04427 Version 2

Safety Recall: Rear Side Marker Light Is Not Working

Supersedes 16-058, dated July 9, 2016, to revise the information highlighted in yellow

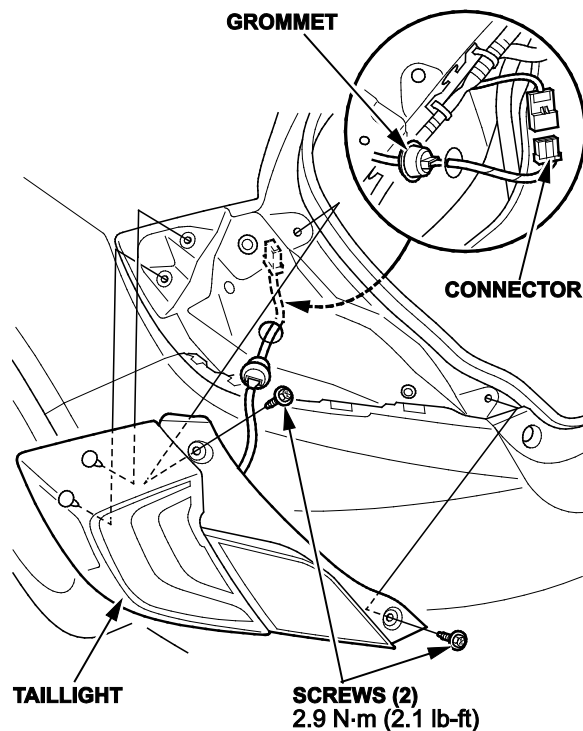
1. Remove the trunk rear side trim panel.
2. Disconnect the connector.

3. Remove the grommet.
4. Remove the taillight.
5. Install the grommet and connect the connector.
6. Install a new taillight, then torque the screws to **2.9 N-m (2.1 lb-ft)**.

7. Install the trunk rear side trim panel.
8. If necessary, repeat steps 1 thru 7 for the opposite side.
